**DRAFT AMENDMENT 58 & DA0472/2019 – 40520 TASMAN HIGHWAY,
ST LEONARDS – REPRESENTATION**

Objection to the application Ref: DA0472/2019, for permit application for a 30 lot rural residential application at 40520 Tasman Highway, St Leonards advertised on

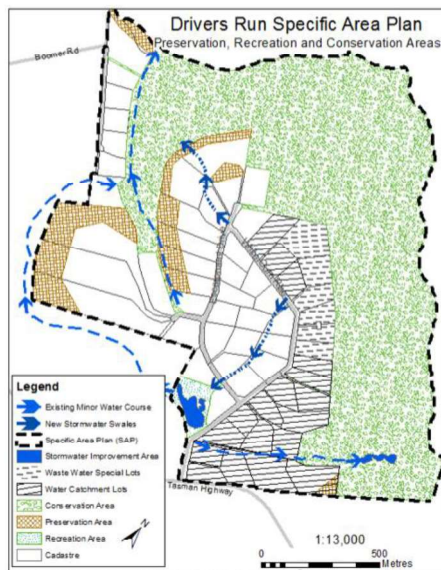
The advice of TasWater and the costs involved to upgrade and extend the existing reticulated water supply does not raise any unusual engineering issues. The topography is not unusual and does not prevent supply. The concern from TasWater in relation to the existing pump station at the Distillery Creek water treatment plant, is not unusual, in that during power outages, it is typical that water supply is affected during a bushfire. This is not a stand-alone event. Contingencies in the event of power failure is a general concern that needs further consideration of TasWater and is not isolated to this proposal alone. If that were the case, then all land is not capable of being connected due to the risk of a power outage in the event of a bushfire event. Therefore, reticulated water supply should be connected to the subdivision and the Amended SPAN (highlighted in RED) as included must

be conditioned on any approval. It is unclear by the draft permit, whether this is to be required or not.
